Written Submission to the Planning Committee — 9 July 2026

Application DM/25/2626 — 42 Hurst Road, Hassocks

Submitted on behalf of the residents of 44 Hurst Road — Objection

Exhibit A — Proposed 'Garden House' superimposed on the applicant's 'As Proposed OS & Block Plan' (1684 3.001 Rev B)

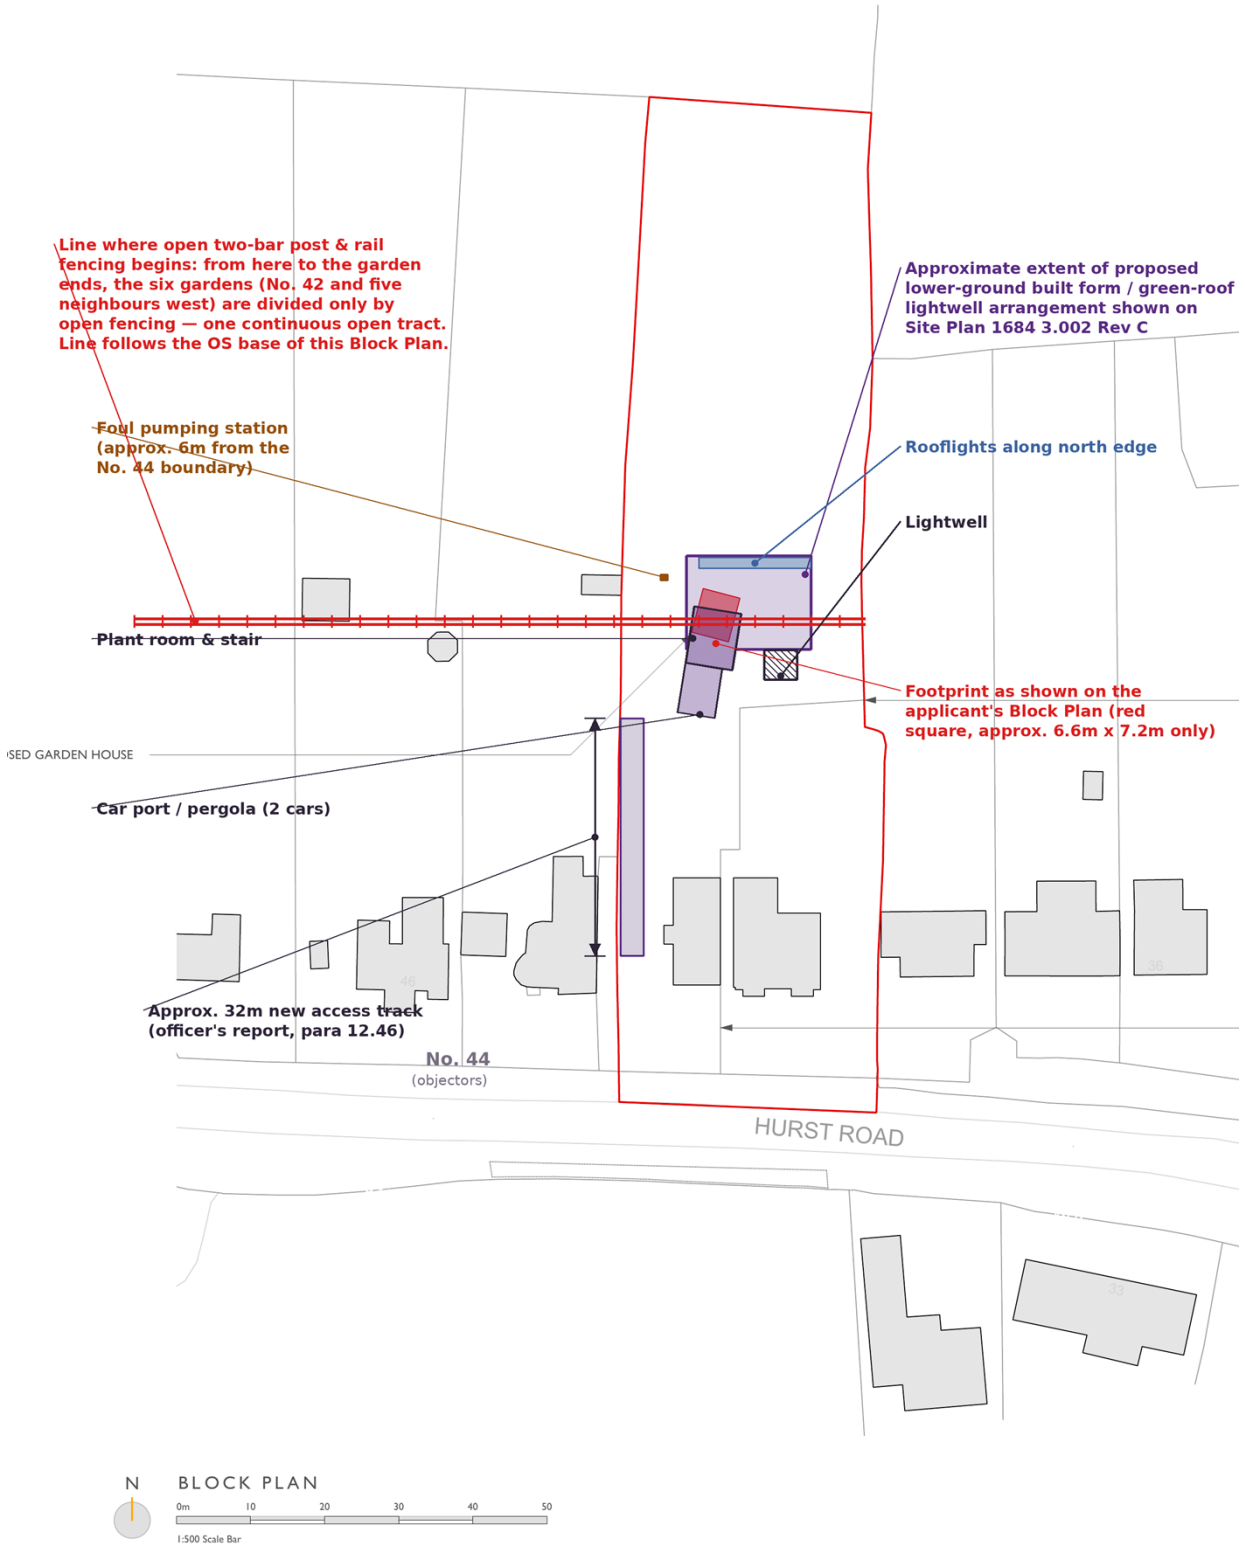
- The real benefit is one net additional dwelling — the side dwelling is already permitted under DM/24/1748.
- The existing house's rear garden shrinks from over 100 metres to 18 metres; the dwelling sits in the open rural tract shared by six gardens, beyond the line no other dwelling crosses (Exhibits A and B; Exhibit C, Photo 3).

6. The open tract, and precedent. In two years this plot has moved from one dwelling towards, if approved, three. The Edwardian house's rear garden of over 100 metres shrinks to 18 metres (10.12), smaller than its neighbours' (12.40). From mid-garden to the garden ends, the six gardens — No. 42's and five neighbours' — from the middle gardens we are divided only by open two-bar post and rail fencing, forming one continuous open rural tract; the proposed dwelling and most of its curtilage sit beyond that line, in open meadow (Exhibits A and B; Exhibit C, Photo 3). No other dwelling in this part of Hurst Road stands beyond it — and the same arguments would justify every large garden on the road.

Photo 2 — the application site
The land proposed for the backland dwelling: unmanaged meadow grassland beyond the established garden ends.

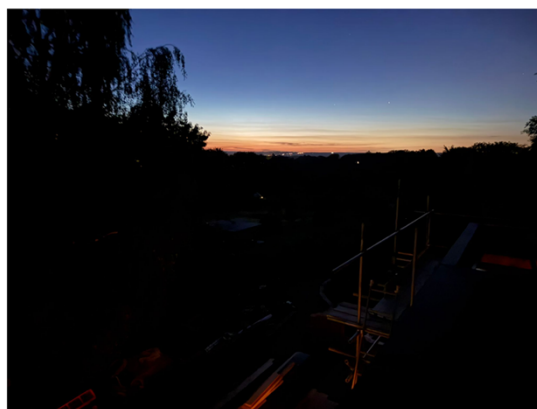
Photo 1 — view north from No. 44
Open two-bar post & rail fencing at the garden end, with open paddock beyond. This fence line runs across six gardens: No. 42 and five neighbours to the west (shown red on Exhibit A).
